SPECIAL WEAPONS AND TACTICS
(SWAT) POLICE STATION
HILLA, IRAQ

SIGIR PA-05-018
JANUARY 30, 2006

SUBJECT: Report on Project Assessment of the Special Weapons and Tactics (SWAT)
Police Station in Hilla, Iraq (Report Number SIGIR-PA-05-018)

Site Photo 17. Generator Unit with Mesh Enclosure

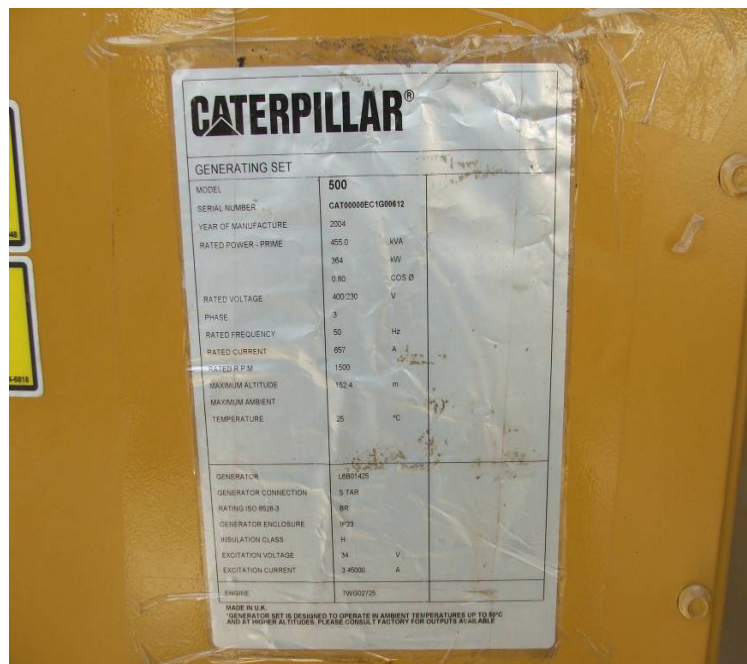
The engine block factory nameplate showed the Engine Serial Number as 7WG02725, although the engine block serial number was partially painted over. For illustrations of the paper copy of the generator nameplate and the engine block factory nameplate, see Site Photos 18 and 19, respectively.

Site Photo 20. Cracks in Concrete Sidewalks of Renovated Building #2

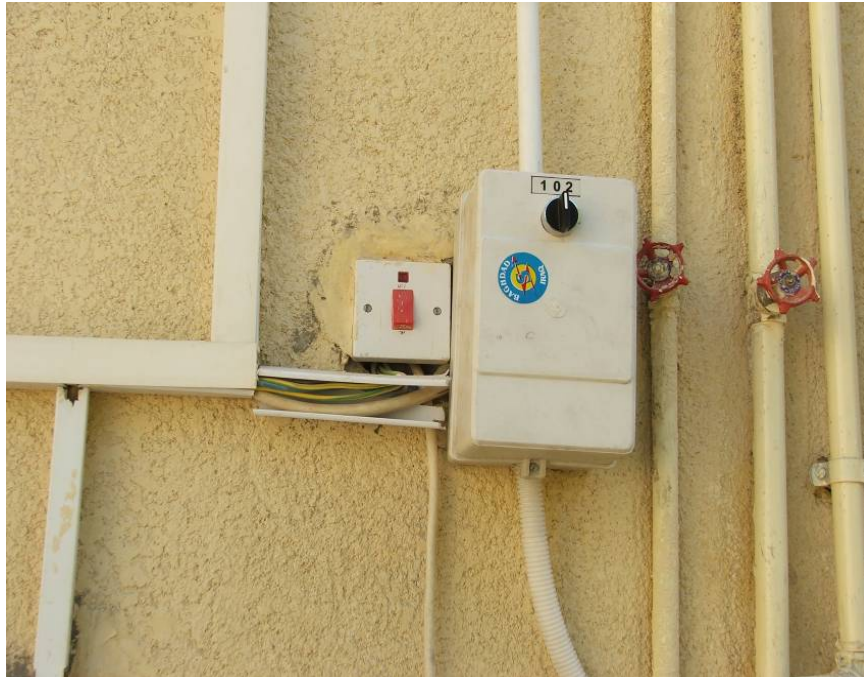
The contract's SOW required the renovation of the remaining buildings after the demolition of the damaged buildings. The SOW stated, "the second phase is the renovation of remaining buildings to temporarily house SWAT personnel as described in the attached Bill of Materials (BOM)." A complete assessment of the renovation of the existing facilities was not completed, although we conducted a walk through of the renovated buildings. Observations of cracks in the new side walks, cracks in the stucco exterior of the building, improperly installed stairwell railings (similar installation to the sleeping quarter and operations room facility), and cracks in the interior security walls are signs of poor workmanship during the rehabilitation of the facilities. For illustrations of the cracks in the front of renovated building #2 and in the interior security walls behind the Vehicle Affairs building, see Site

Photos 20 and 21, respectively. Site Photo 22 illustrates exposed electrical wires located in the exterior of renovated building 10.
